CERTIFICATE OF APPROPRIATENESS**Application Date:** October 31, 2025**Applicant:** Sam Gianukos, agent for Ed Goerig, owner.**Property:** 505 Teetshorn Street, Lot 15, Block 24, Woodland Heights Subdivision. The property includes a historic 1,269 square foot, one-story wood frame single-family residence situated on a 6,365 square foot (50' x 127.3') interior lot.**Significance:** Contributing craftsman residence, constructed circa 1915, located in the Woodland Heights Historic District.**Proposal:** Alteration – Addition

The applicant is proposing to construct a 2,595 SF two-story addition (Adding 01 SF to the first floor and 1,994 SF to the second) with an attached two-story garage. The max ridge height of the addition will be 31'-10" and the eave height 23'-6".

Recommendation: Approval with conditions: the second-floor projection encroaching over the existing historic structure be eliminated from the proposed design and for wood siding on existing structure to remain and only be repaired if needed by verifying with staff.

PROPOSED SITE PLAN

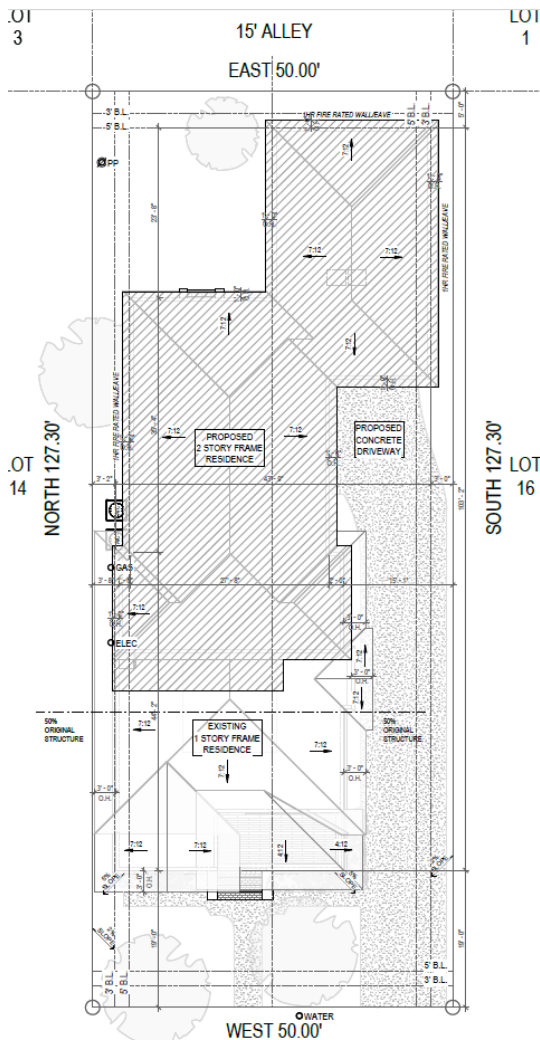
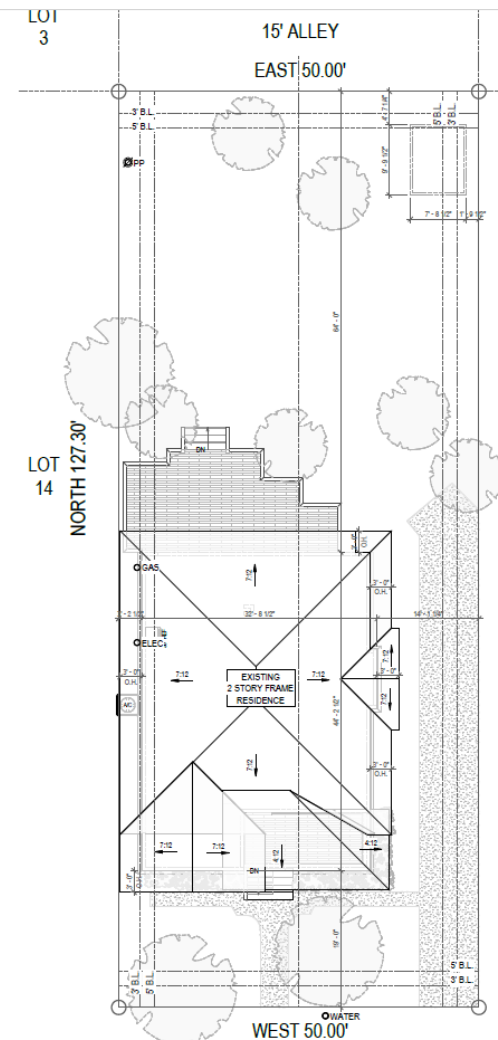
The addition appears to dominate the original structure, which conflicts with the principle of design compatibility. Guidelines emphasize that additions should be visually subordinate to the historic home and maintain its character. In this case, the vertical expansion seems intended to maximize square footage rather than preserve the historic nature of the property. The new property owner is a home builder and is building this home to maximize sq ft as the impervious cover is at 64%, that also raises flooding risk to our home and our neighbors homes due to increased runoff during rain events. Something we ensured with our design and with considerable cost to us would not impact our neighbors, which hasn't so far in the 6 months we have lived in the home.
